S92 RESPONSE – 2127 KAIPARA COAST HIGHWAY, KAKANUI (BUN60406128)

Further to your instruction, we are pleased to provide this response to the transportation matters raised by Auckland Council in their Further Information Request (the 'request') dated 27 June 2024. We respond to 'Traffic' Items 30, 68 to 70 and 'Transportation' Questions 8 to 12 of the request as follows.

Figure 1: Two-way Accessways and Passing Bay Locations

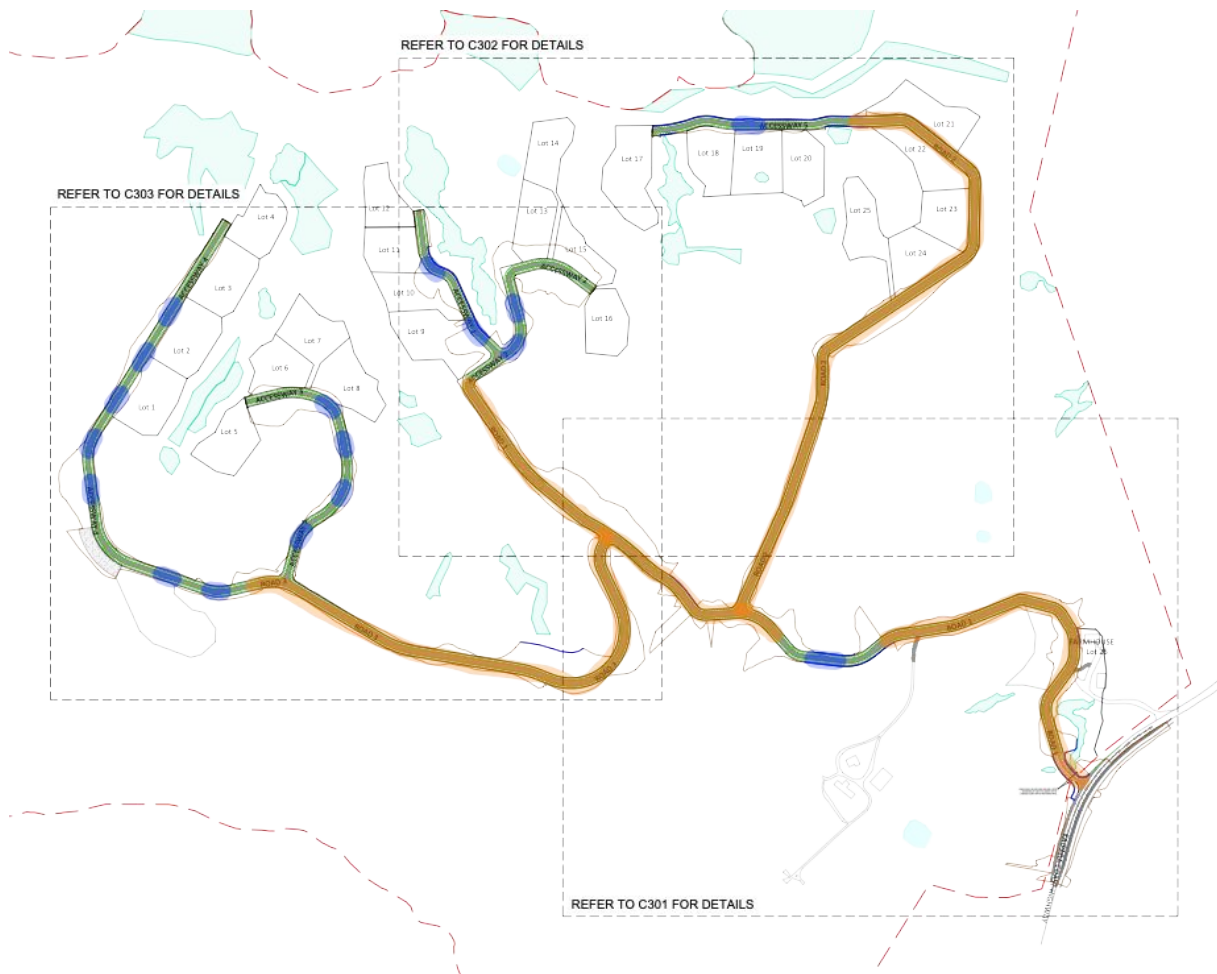
"The Section 92 Response includes attachments to the original (draft) TIA which were missing from the original draft provided. These include Roding Layout Plans for the proposed subdivision.

The TIA confirms technical parameters for the new subdivision roads, including maximum gradients, general widths and the proposed provision of passing bays at 'intermittent' locations along the accessways. However, the roding layout plans provided do not include indicative locations for passing bays.

New Zealand Standard NZS 4404: 2010 – Land Development and Subdivision Infrastructure Table 3.2 recommends the provision of passing bays up to every 50 metres on a single lane accessway serving up to 6 residential units. E27 of the AUP(OP) also provides specific standards for passing bay locations and design. Both would infer the provision of multiple passing bays along the lengths of each of proposed subdivision accessways.

- a) Assessment of the proposed subdivision roads according to the requirements of NZS 4404: 2010 for subdivision roding design standards, including the provision of passing bays.*
- b) Updated roding layout plans showing indicative locations for passing bays along each of the accessways."*

Agreed, it is difficult to see where passing bays are proposed on the current plans. Despite that, the passing bays are provided. To assist, we have reviewed the civil engineering set and marked up the following:

- The location of two-way sections of accessway, and
- The location of passing bays on single lane sections of accessway.

The two-way sections of accessway are highlighted orange while the passing bay locations are highlighted in blue. Given the number of lots served by each accessway, these provisions are considered acceptable.
